Access Compliance Report Public Rights-of-Way (Curb Ramps)

Main Street: GREENVALE Cross Street: MEADOWOOD Location: S

ADA ID: RPRK211018150547 Ramp Type: Type 1 - Perpendicular Diagonal Initial Pass/Fail: Fail Overall Compliance: No Severity Score: 45

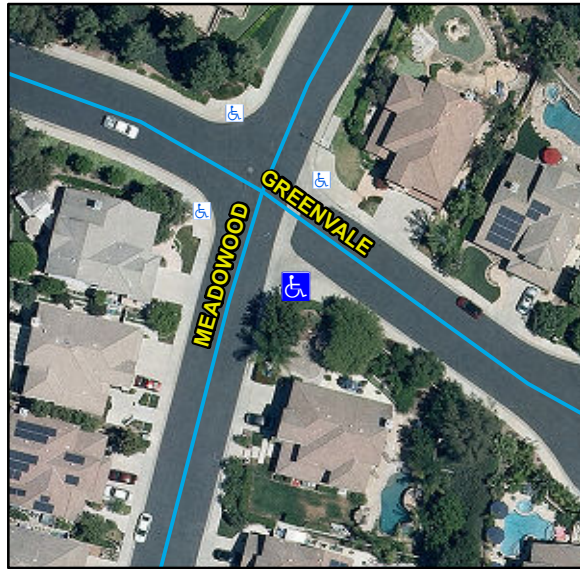
Compliance	Description	Data	Compliance	Description	Data
N/A	Ramp Length (in)	63	N/A	Flare Type LT	
Yes	Ramp Width (in)	48			N/A
No	Ramp Run Slope (%)	11.7	N/A	Flare Slope LT (%)	N/A
No	Ramp Cross Slope (%)	10.8	N/A	Flare Traversable LT	N/A
N/A	Landing Present	N/A	N/A	Flare Type RT	
N/A	Landing Length (in)	N/A			N/A
N/A	Landing Width (in)	N/A	N/A	Flare Slope RT (%)	N/A
N/A	Landing Run Slope (%)	N/A	N/A	Flare Traversable RT	N/A
N/A	Landing Cross Slope (%)	N/A	N/A	DWS Provided	N/A
N/A	Landing Movement Obstructed?	N/A	N/A	DWS Contrast	N/A
	Landing Movement Type	N/A	N/A	DWS Length (in)	N/A
N/A	Landing Shared	N/A	N/A	DWS Full Width	N/A
N/A	Clear Space	Yes	N/A	DWS Offset Left (in)	N/A
N/A	Clear Space To Crosswalk (in)	N/A	N/A	DWS Offset Right (in)	N/A
N/A	Marked Crosswalk 1	No	N/A	Marked Crosswalk 2	No
	Crossing 1 Direction	NE		Crossing 2 Direction	NW
	Marked Crosswalk 1 Width (in)	N/A		Marked Crosswalk 2 Width (in)	N/A

N/A	Ramp Inside Crosswalk 1	N/A	Yes	Ramp Inside Crosswalk 2	N/A
	Crossing 1 Slope (%)	4.9		Crossing 2 Slope (%)	2.4
	Crossing 1 Cross Slope (%)	6.6		Crossing 2 Cross Slope (%)	3.9
N/A	Gutter Ponding	N/A	No	Curb Slope	5.3
No	Gutter Lip Height (in)	0.25		Road Run Slope (%)	10.4
N/A	Gutter Run Slope (%)	N/A		Road Cross Slope (%)	3.8
N/A	Gutter Cross Slope (%)	N/A			
Yes	Overall Surface Condition: Acceptable		No	Perp Joint Present	No
	Cross Gutter Present?	Yes		Spandrel Present?	Yes
	Replace Cross Gutter?	No		Replace Spandrel?	No

Remove & Replace Curb Ramp With Two New Directional Ramps or Equivalent.
